# Access Compliance Report

## Public Rights-of-Way

### (Curb Ramps)

Intersection ID: 3276	Main Street: LAKE_SPRING_AV	Cross Street: W_W_T_HARRIS_BV	Location: SW
ADA ID: E4BE99BA04B8	Ramp Type: Perp	Initial Pass/Fail: Fail	Overall Compliance: No
			Severity Score: 10

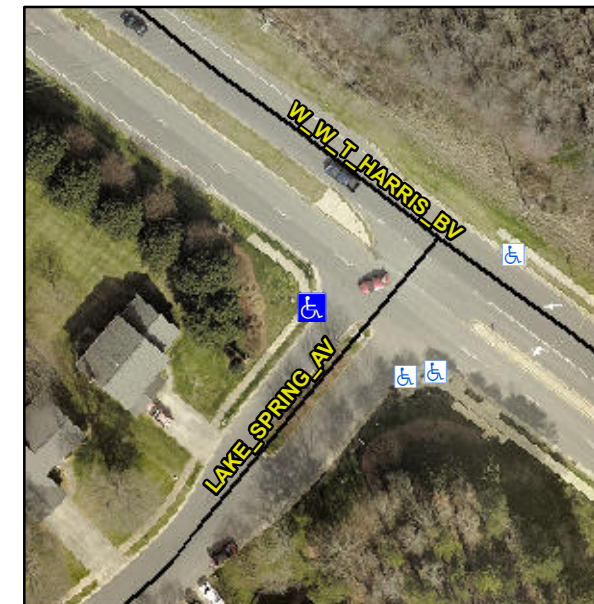
**R304.5.1, R304.5.3**

Compliance	Description	Data	Compliance	Description	Data
N/A	Ramp Length (in)	98.0	Yes	Ramp Slope (%)	7.3
No	Ramp Width (in)	46.5	No	Ramp XSlope (%)	4.1
N/A	Flare Type LT	N/A	N/A	Flare Type RT	N/A
N/A	Flare Slope LT (%)	N/A	N/A	Flare Slope RT (%)	N/A
N/A	Flare Traversable LT?	N/A	N/A	Flare Traversable RT?	N/A
N/A	Landing Length (in)	N/A	N/A	DWS Provided?	N/A
N/A	Landing Width (in)	N/A	N/A	DWS Contrast?	N/A
N/A	Landing Slope (%)	N/A	N/A	DWS Length (in)	N/A
N/A	Landing X Slope (%)	N/A	N/A	DWS Full Width?	N/A
N/A	Landing Curb? (Y/N)	N/A	N/A	DWS Offset (in)	N/A
N/A	Shared Landing?	N/A			
N/A	Gutter Ponding?	N/A	N/A	Gutter Slope (%)	N/A
N/A	Gutter Lip Ht (in)	N/A	N/A	Gutter X Slope (%)	N/A
N/A	Painted X Walk1?	No	N/A	Painted X Walk2?	N/A
	X Walk 1 Direction	To SE		X Walk 2 Direction	N/A
N/A	X Walk 1 Width (in)	N/A	N/A	X Walk 2 Width (in)	N/A
	X Walk 1 Slope (%)	1.4		X Walk 2 Slope (%)	N/A
	X Walk 1 X Slope (%)	1.3		X Walk 2 X Slope (%)	N/A

**Remove & Replace Entire Ramp.**
